# TDECQ Reference Receiver Main Tap Location Constraint

Phil Sun, Credo Semiconductor  
IEEE 802.3cd ad hoc, April 25th 2018

Figure 139–5—TDECQ reference equalizer functional model

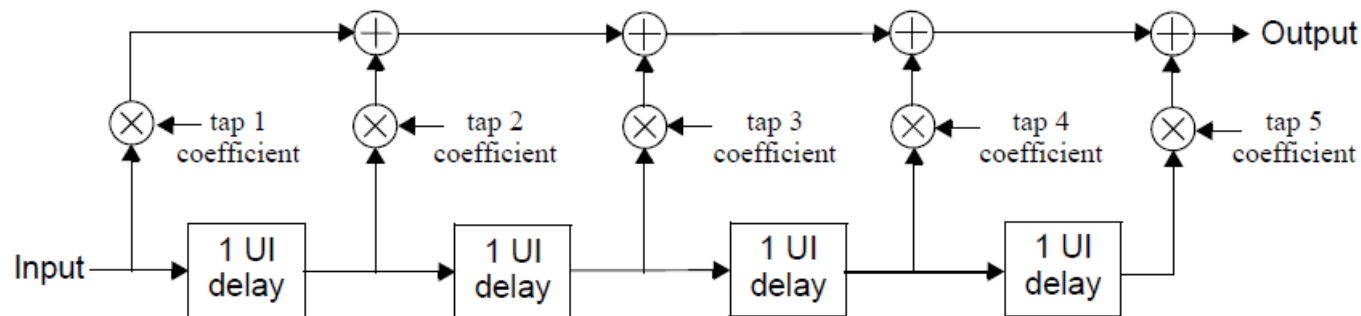
The reference equalizer for 50GBASE-FR and 50GBASE-LR is a 5 tap, T spaced, feed-forward equalizer (FFE), where T is the symbol period. A functional model of the reference equalizer is shown in Figure 139–5. The sum of the equalizer tap coefficients is equal to 1. Tap 1, tap 2, or tap 3, has the largest magnitude tap coefficient.

- Changes:  
**Tap 1 or tap 2**, has the largest magnitude tap coefficient.

Figure 140–4—TDECQ reference equalizer functional model

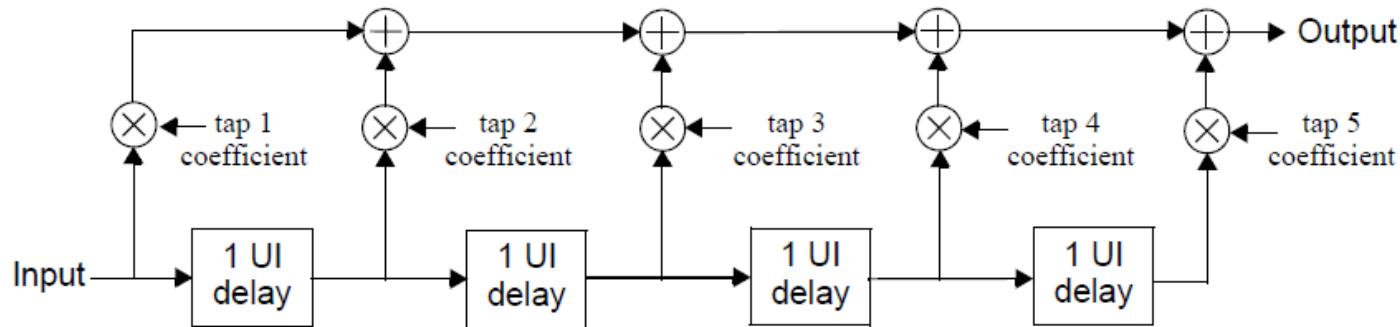
The reference equalizer for 100GBASE-DR is a 5 tap, T spaced, feed-forward equalizer (FFE), where T is the symbol period. A functional model of the reference equalizer is shown in Figure 140–4. The sum of the equalizer tap coefficients is equal to 1. Tap 1, tap 2, or tap 3, has the largest magnitude tap coefficient.

- Changes:  
**Tap 1 or tap 2**, has the largest magnitude tap coefficient.
